STAFF REPORT: AUGUST 10, 2022 MEETING
APPLICATION NUMBER: #22-7936 & #22-7938
ADDRESS: 3746-3752 SECOND AVENUE
HISTORIC DISTRICT: WILLIS-SELDEN
APPLICANT: NAJIM SAYMUAH
PROPERTY OWNER: GRAND DETROIT HOLDINGS LLC & DETROIT LAND BANK AUTHORITY
DATE OF PROVISIONALLY COMPLETE APPLICATION: JULY 17, 2022
DATE OF STAFF SITE VISIT: JUNE 29, 2022

SCOPE: ERECT MULTI-UNIT TOWNHOUSE BUILDING AND REHABILITATE EXISTING BUILDING

3752 and 3746 Second Avenue, current appearance (staff site visit, 7/29/2022)

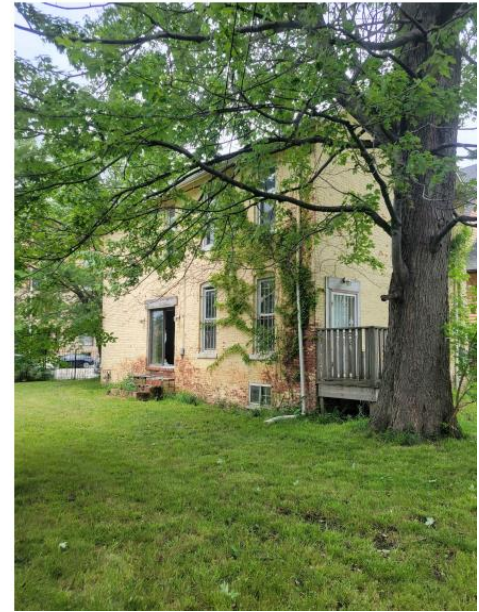
- As stated above, the applicant is proposing to add a 10'-0"-wide concrete driveway to the side/north of the historic home. This driveway will accommodate three parking spots. Staff does not think that historic driveways are typically 9'-0" wide. It is also noted that the four parking spots proposed for the rear yard are 9'-0" wide.

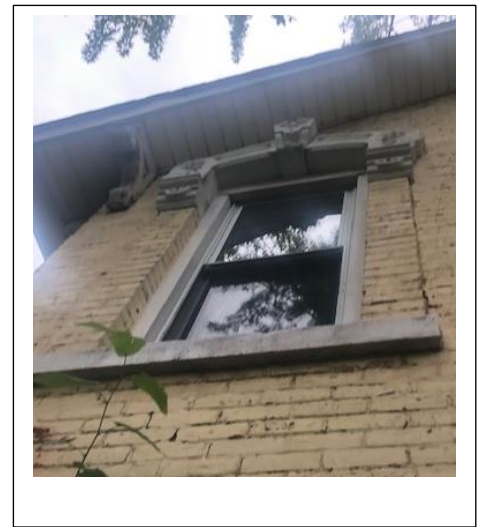
- *Front/West Elevation*
 - At first-story projecting bay, paint existing vinyl cladding (color not specified)
 - At first-story projecting bay, replace existing flat roof and aluminum gutter with new (new gutter and roof type not specified)

- Replace existing wood front porch with new synthetic steps, decking, and railing (drawings of new porch not provided)
 - Replace front door and sidelites to rough opening with new wood door and sidelites

- Remove plywood from front door transom and install a new decorative synthetic (Fipon) cornice
 - At second story decorative lintels, clean and repaint (cleaning method and color not specified)

- The applicant is proposing to "sandblast" the brick at the historic building in order to remove the paint. Please note that this method of cleaning is highly inappropriate and will likely permanently damage the building's brick exterior walls. See the National Park Service's Preservation Brief #6 [Preservation Brief 6: Dangers of Abrasive Cleaning to Historic Buildings \(nps.gov\)](#) for additional information. Per the Secretary of the Interior, "chemical or physical treatments, such as sandblasting, that cause damage to historic materials shall not be used. The surface cleaning of structures, if appropriate, shall be undertaken using the gentlest means possible." Staff recommends that the applicant identify a more appropriate method for removing the existing paint from the building's brick exterior walls and decorative front elevation window lintels or that the building's exterior walls simply be cleaned and repainted an appropriate color

- The eaves at the main roof and the front elevation projecting bay include decorative brackets. Also, the soffits are currently wrapped with aluminum. The application proposes to replace both roofs. Staff recommends that the decorative wood brackets be retained and, if the aluminum wrapping at the soffit is to be removed, that the existing wood underneath be retained any deteriorated areas be repaired in kind

- The applicant is seeking to install a decorative Fipon/synthetic cornice in the transom area at the primary/west elevation, above the entry door. It is staff's opinion that the element would present a false historical appearance and would compete with the existing historic decorative window lintels at the front elevation's second-story windows. Staff recommends that a simple fixed, wood-frame glass transom be installed at that location.

- The applicant is seeking to replace the existing non-historic wood porches/steps at the front and rear elevation with new synthetic/composite porches. Staff supports the proposed treatment at the rear elevation as it a secondary entrance and will not be visible from the right-of-way. However, it is staff's opinion that this treatment is not appropriate for the front elevation as the porch will be

highly visible and will not present an appearance that is appropriate to an early 20th century masonry residence. Also, more appropriate materials are readily available to the applicant. Staff recommends that the applicant refer to existing porches at nearby contemporaneous buildings to support the development of a new design for a simple masonry or wood porch which is more compatible with the existing residence.

- Landscaping/specific species at both parcels
- Abrasive methods, to include sandblasting, shall not be employed to clean the historic building’s exterior. Rather, the applicant shall identify a more appropriate method for removing the existing paint from the building’s exterior walls and decorative front elevation window lintels or that the building’s exterior walls be cleaned and repainted an appropriate color. HDC staff shall be afforded the opportunity to review and approve the new proposal to clean and/or paint the building’s exterior walls prior to the issuance of the project’s permit

- The decorative brackets at eaves at the main roof and the front elevation projecting bay shall be retained. If the aluminum wrapping at these soffits is to be removed, the remaining wood soffit underneath shall be retained and any deteriorated areas shall be repaired in kind

- The decorative Fipon/synthetic cornice shall not be installed in the transom area at the primary/west elevation, above the entry door. Rather a simple fixed, wood-frame glass transom shall be installed at that location.

- The applicant shall refer to existing porches at nearby contemporaneous buildings to support the development of a new design for a simple masonry or wood porch which is more compatible with the existing residence. HDC staff shall be afforded the opportunity to review and approve the new front porch design prior to the issuance of the project's permit.
